T.I. no.: 2021 - 03 Updated: -	Topic: Mounting bracket for grinder cover
-----------------------------------	---

Date: 08.03.2021	Priority	Need for action
Affected machines: SCP	High	As soon as possible
From serial number: 2023../	Medium	X On next visit to the machine
As of date:	X Low	FYI only

Grinder cover fastened with PT screw

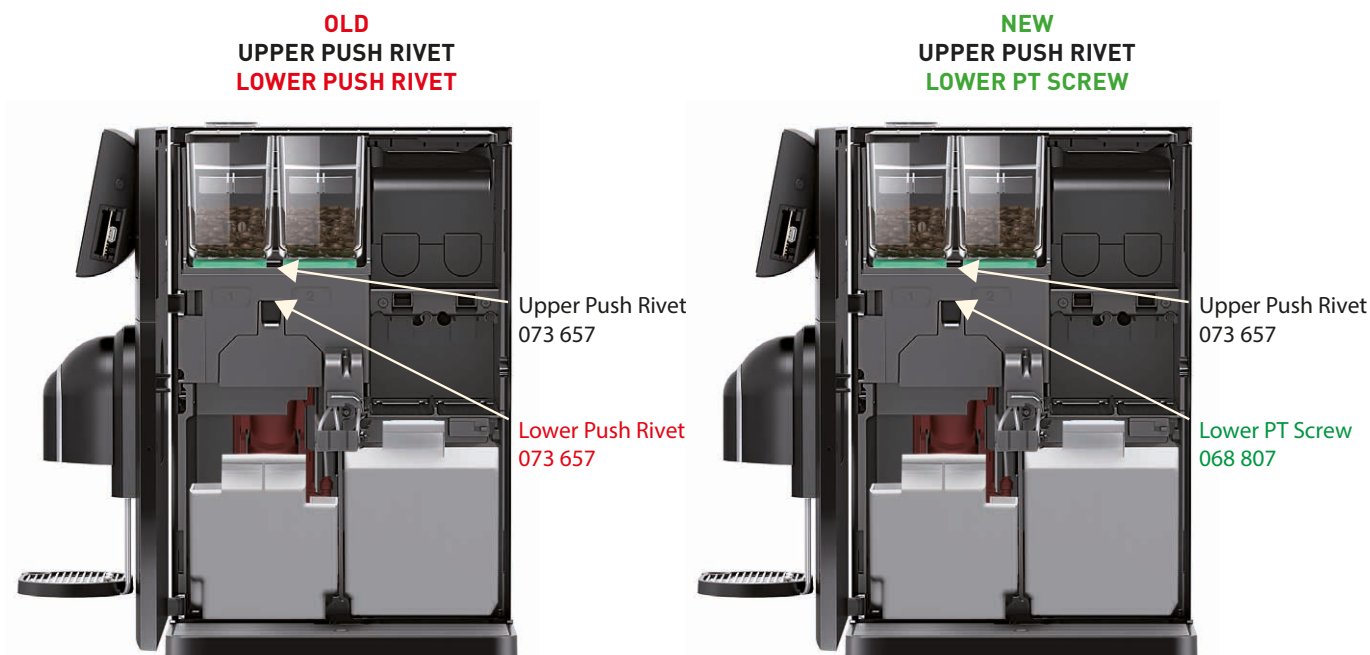
Grinder cover 072 901 of the Schaeerer Coffee Prime was previously fastened with two push rivets 073 657. The lower push rivet did not sufficiently perform its holding function and frequently fell out.

From serial number 2023/XXXX, lower push rivet **073 657** will be replaced by PT screw **068 807**. The upper push rivet remains unchanged.

PU screw **068 807** is self-tapping and can be screwed into the existing hole.

- ▶ Pull out brewing unit holder drawer **pos. 3**
- ▶ Remove push rivet **pos. 1** and PT screw **pos. 2**
